# RotorSport UK Ltd

## Service Bulletin

<b>SB No.: 037 issue 1</b>	CCAR No.: None	Classification: <del>OPTIONAL</del> or <b>RECOMMENDED</b> or <del>MANDATORY</del>
Aircraft type & model (applicability) RotorSport UK MT-03	Aircraft serial Nos. effected RSUK/MT-03/all (only if required – see text)

Installation photographs

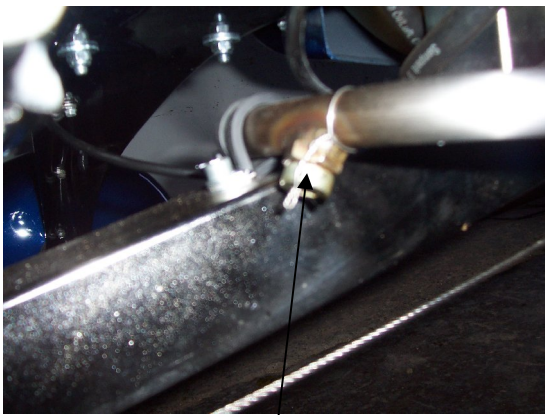
Temporary relocation of the oil cooler to give access for the right-angle drill

Drain-plug wirelocked

Finished installation

- 2) From installation kit M.BE52 offer-up the new transfer pipe RSD2066 and rubber pipe sections to determine the most accessible location for a single P-clip on the centre-line above the keel tube just aft of the suspension bow. It will be advantageous to temporarily relocate the oil cooler to enable access by a right-angle power drill fitted with a stub-length drill-bit. Mark-out then drill a hole 5.0mm dia. aft of the suspension bow so that the P-clip can be fitted around the pipe with its fastener screw aft of the clip ring (the opposite direction to that seen on MTOsport). Tap the hole M6. If necessary the rubber pipes may be shortened to optimise installation access.

- 3) Finish the assembly by fitting new pipe clips and fastening the M6 screw using Loctite 243. Ensure that the oil-cooler is securely refitted using new nyloc nuts.

- 4) Refill the fuel tanks, check for leaks and sample a small amount of fuel to ensure there is no fuel contamination and that the two fuel-sampling points close properly. Tighten and wire-lock the single fuel drain-plug as shown in the photographs at the end of this document (note the sealing washer on the drain plug).
